TOWN OF PARADISE VALLEY

Smoke Tree Resort Statement of Direction

Town Council Meeting
May 24, 2018

SOD CONSIDERATION POINTS — OPEN SPACE CRITERIA

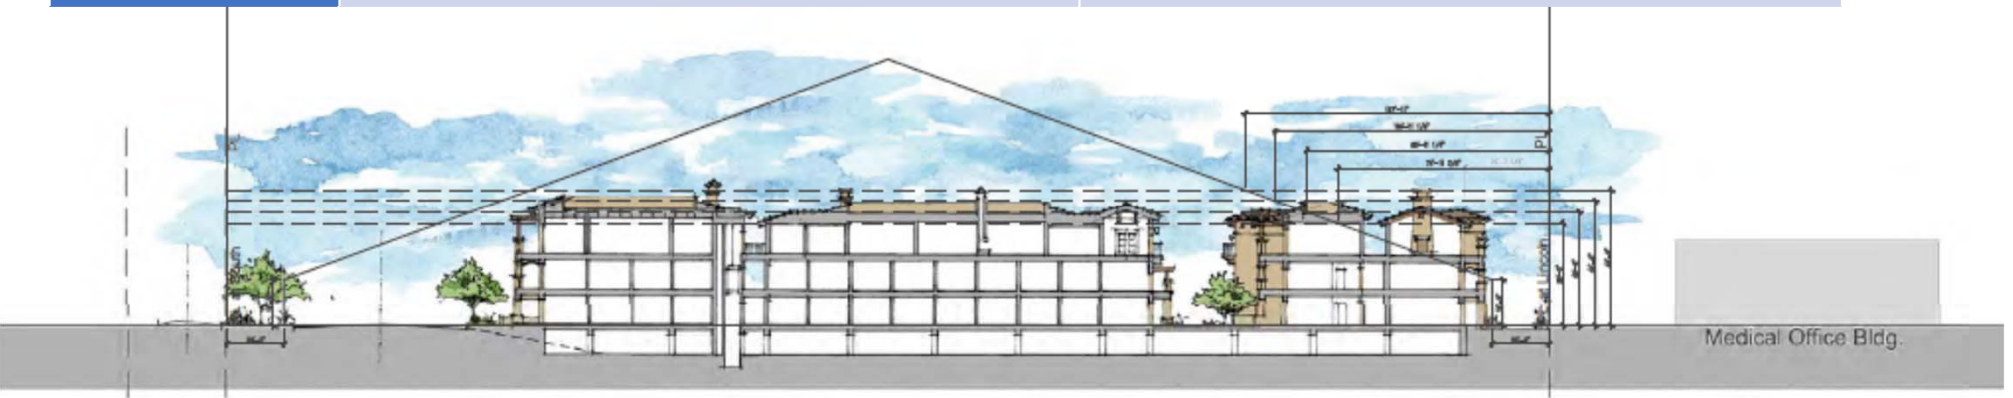
Topic	Town Code/Special Use Permit Guideline/Town Policy Existing Condition	Proposal by Applicant Suggested SOD Focus
Open Space Criteria - Viewshed	Open Space Criteria is reviewed as a means to preserve viewsheds, encouraging the massing of tall structures in the center of the site (SUP Guideline). SOD to address massing/scale (SUP Section 1102.3.B.4 Zoning Ordinance)	Open Space Diagram Site Section provided illustrates criteria is not met on the south and east sides of the site and may not be met for some buildings on the west and north sides. The owner of the Andaz expressed concerns over the height and loss of views along the south property line
	Existing structures comply	The Planning Commission should evaluate the impact to adjoining properties of any encroachment outside of the imaginary plane suggested by the Open Space Criteria

Buffering

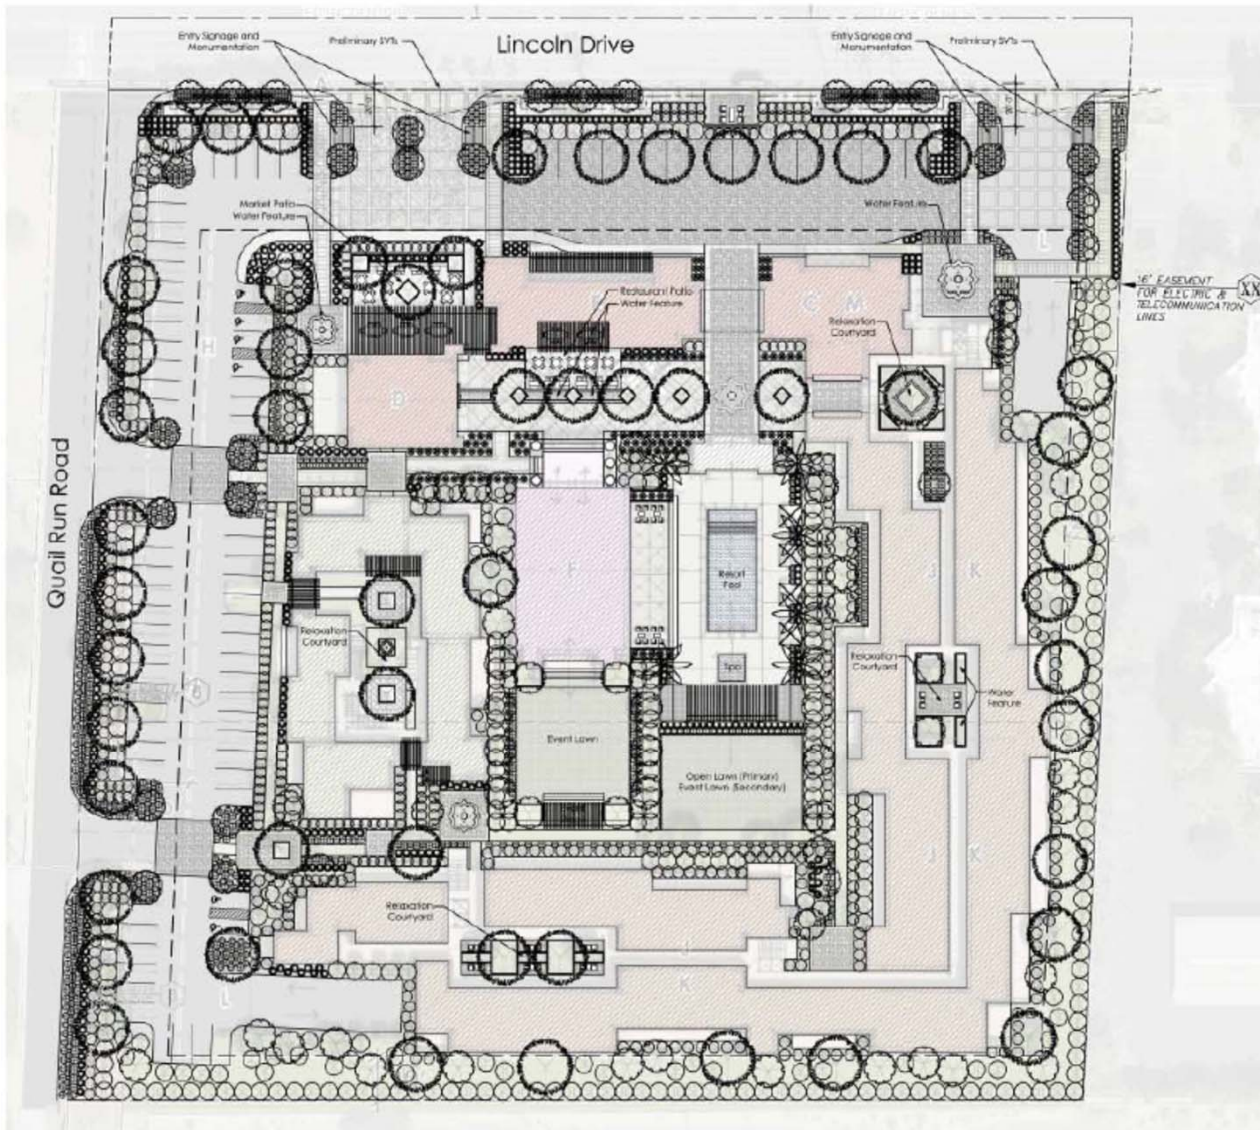
Topic	Town Code/Special Use Permit Guideline/Town Policy Existing Condition	Proposal by Applicant Suggested SOD Focus
Landscape/ Buffering	50' along major roads 30' along local roads (SUP Guideline)	<ul style="list-style-type: none"> • 20' along Lincoln Dr (includes portion in the right-of-way) • 10' and 25' along Quail Run (includes portion in the right-of-way)
	General Plan Policy EP 6.1.1.3 Mature Landscape Preservation. The Town shall require new development and redevelopment to preserve mature indigenous and compatible landscaping on-site where feasible. Several large trees on the site.	In addition to rear/side property line buffering, particular attention shall be paid to the buffer along Lincoln Drive based on the proposed Visually Significant Corridor study and the improvements proposed at the Ritz property just to the north, including replacement of any buffer should the landscaping die.

Existing buffers <ul style="list-style-type: none"> • 7' Lincoln Dr (in right-of-way) • 33' or greater Quail Run Rd • 10' and 33' or greater in rear • 0' to 10' east side Existing tall hedges act as perimeter buffers	The submitted narrative explains that the existing vegetation condition is not recommended for salvage due to age, size, and diseased quality. Evaluation of the existing mature trees shall be reviewed.
